# Access Compliance Report

## Public Rights-of-Way

### (Curb Ramps)

Intersection ID: 4829	Main Street: ARKLOW_RD	Cross Street: SADDLE_TRAIL_LN	Location: S
ADA ID: 58AA6F15EB56	Ramp Type: Perp	Initial Pass/Fail: Fail	Overall Compliance: No
Codes/Mitigation Info/Possible Solution		Field Measurements/Component Compliance

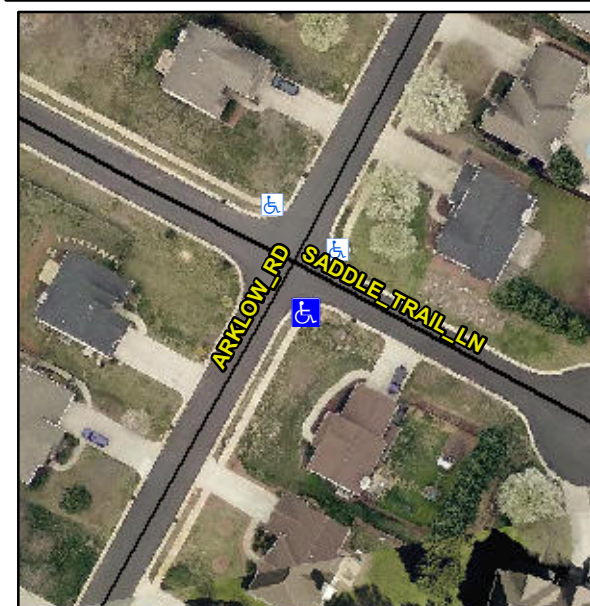
**R304.5.1, R304.5.3**

Compliance	Description	Data	Compliance	Description	Data
N/A	Ramp Length (in)	47.0	Yes	Ramp Slope (%)	6.8
No	Ramp Width (in)	34.0	No	Ramp XSlope (%)	2.1
N/A	Flare Type LT	N/A	N/A	Flare Type RT	N/A
N/A	Flare Slope LT (%)	N/A	N/A	Flare Slope RT (%)	N/A
N/A	Flare Traversable LT?	N/A	N/A	Flare Traversable RT?	N/A
N/A	Landing Length (in)	N/A	N/A	DWS Provided?	N/A
N/A	Landing Width (in)	N/A	N/A	DWS Contrast?	N/A
N/A	Landing Slope (%)	N/A	N/A	DWS Length (in)	N/A
N/A	Landing X Slope (%)	N/A	N/A	DWS Full Width?	N/A
N/A	Landing Curb? (Y/N)	N/A	N/A	DWS Offset (in)	N/A
N/A	Shared Landing?	N/A			
N/A	Gutter Ponding?	N/A	N/A	Gutter Slope (%)	N/A
N/A	Gutter Lip Ht (in)	N/A	N/A	Gutter X Slope (%)	N/A
N/A	Painted X Walk1?	No	N/A	Painted X Walk2?	N/A
	X Walk 1 Direction	To NE		X Walk 2 Direction	N/A
N/A	X Walk 1 Width (in)	N/A	N/A	X Walk 2 Width (in)	N/A
	X Walk 1 Slope (%)	6.0		X Walk 2 Slope (%)	N/A
	X Walk 1 X Slope (%)	5.8		X Walk 2 X Slope (%)	N/A

**Remove & Replace Entire Ramp.**
